ONSITE SEWAGE DISPOSAL SYSTEM

PROPERTY ADDRESS: 14511 MacClintok Court, Glenwood, MD 21738

SUBDIVISION: WARFIELD ESTATES, S-4, BL-A LOT: 21 TAX ID: 04-323254

**RE: Warfield Estates, Lot 21
14511 MacClintock Court
Revised On-site Sewage Disposal System**

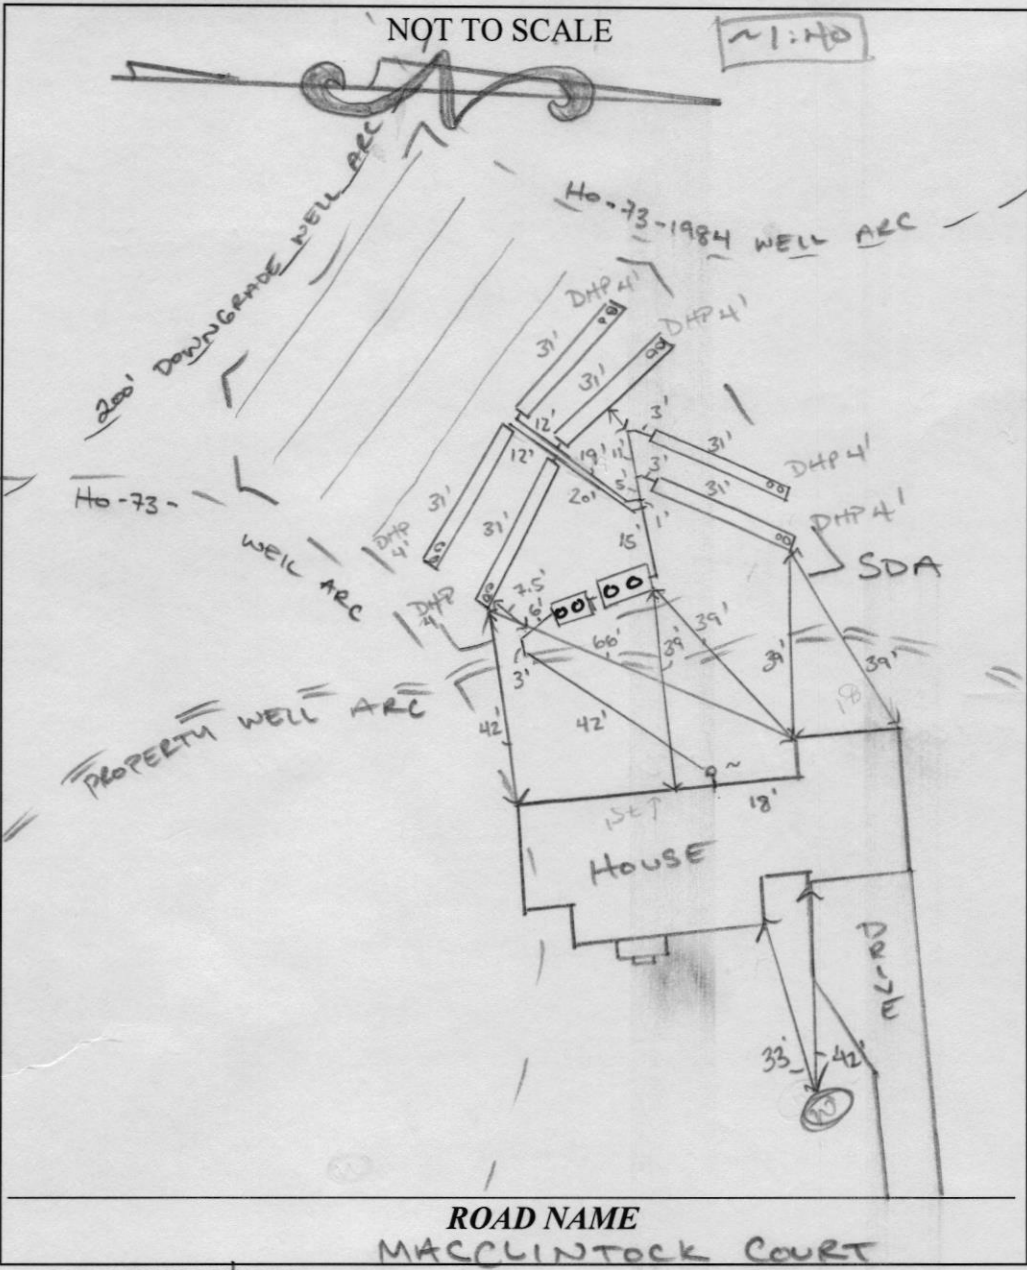
PRE-CONSTRUCTION:

08/16/2021 REMOVE WOOD CHIPS AND REINSPECT CONTOUR FOR LPD TRENCH INSTALL. USE LAZER LEVEL FROM MANIFOLD REGION TO LEVEL 8' TRENCH BOTTOM. OK TO SET TANKS CONFIRMED LATERAL SPECS. ⊕

INSTALLATION: 08/27/2021 ST, SHC TANK + D Box SET. TRENCHES INSTALLED. PUMP/ALARM DHP = N' ALARM WORKS. *NEED TO INSTALL DIGITAL TRENCH OBS PORT. ⊕ 09/21/2021 INSTALLED c/c @ ENDS OF TRENCHES ⊕
